Interactive comment on “Parameter regionalization of a monthly water balance model for the conterminous United States” by A. R. Bock et al.

Interactive comment on Hydrol. Earth Syst. Sci. Discuss., 12, 10023, 2015.

Fig. 1.

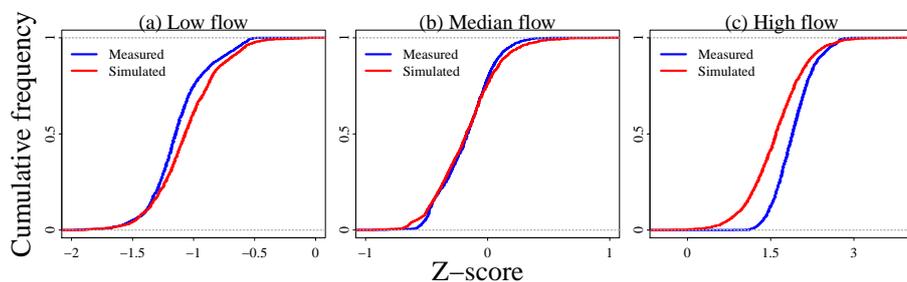
In Figure 11 there is a label error with the ecdfs. "High flow" should be the label above panel C, and "Low flow" should be the label above panel A. I have attached a new figure with the proper labels.
